## Datasheet Errata for the MB9B500/400/300/100/MB9A100 Series Gap between Watch Counter Value and Real Time at Return in Timer Mode, FM3 Family 32-Bit Microcontroller

Part Number
MB9B500/400/300/100/MB9A100 Series

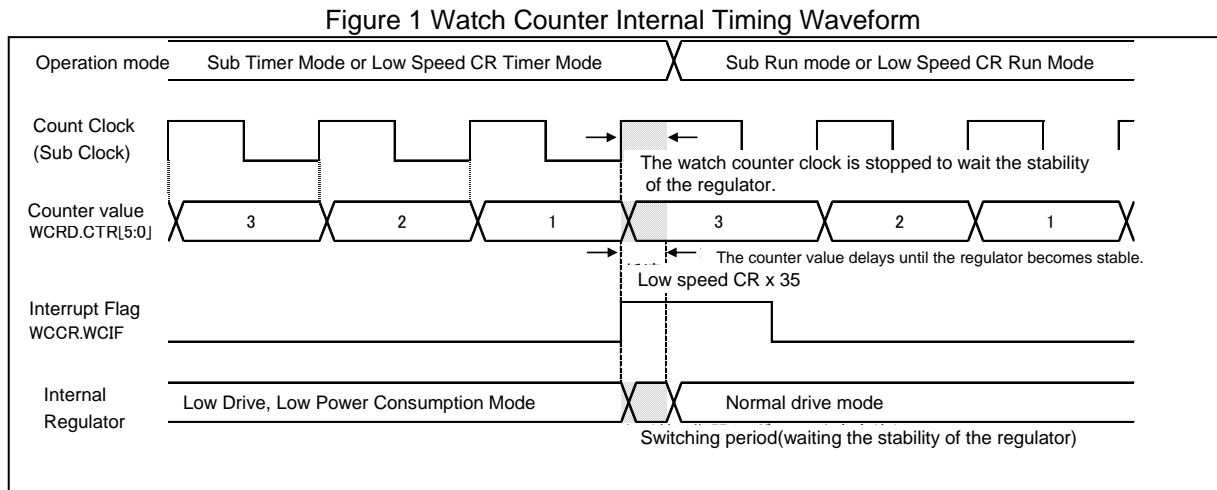
When the watch counter using the sub-crystal oscillator is used in the sub timer mode or the low speed CR timer mode, the value of the watch counter has a “Low speed CR x 35clock” delay (about 350us at waiting for the stability of the regulator) at the return by the interrupt. As a result, a gap occurs between the value of the counter and the real time.

The following figure shows the timing waveform.

At a result, the value of the watch counter delay until the time for the stability of the regulator as shown in the Figure 1. Therefore, a gap occurs between the value of the counter and the real time.

- When the extremely accuracy is required for the count time of the watch counter, use the sub sleep mode or the low speed CR sleep mode.
